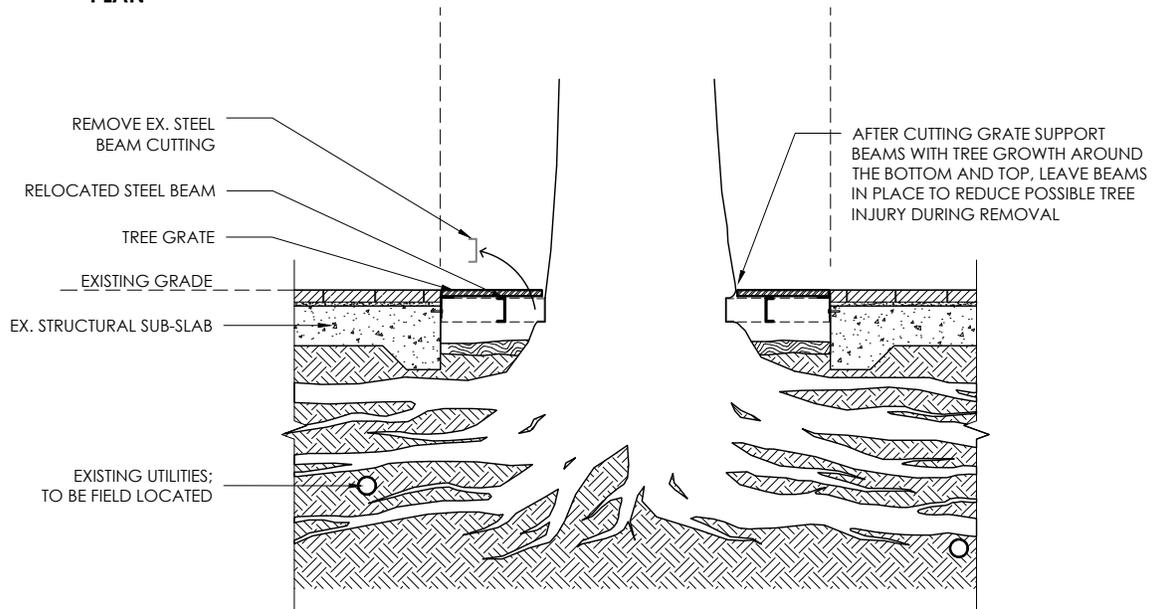
NOTE: RELOCATE STEEL BEAM TO MAXIMUM ALLOWABLE DISTANCE FROM TREE TRUNK. STEEL MODIFICATION TO BE REVIEWED BY STRUCTURAL ENGINEER
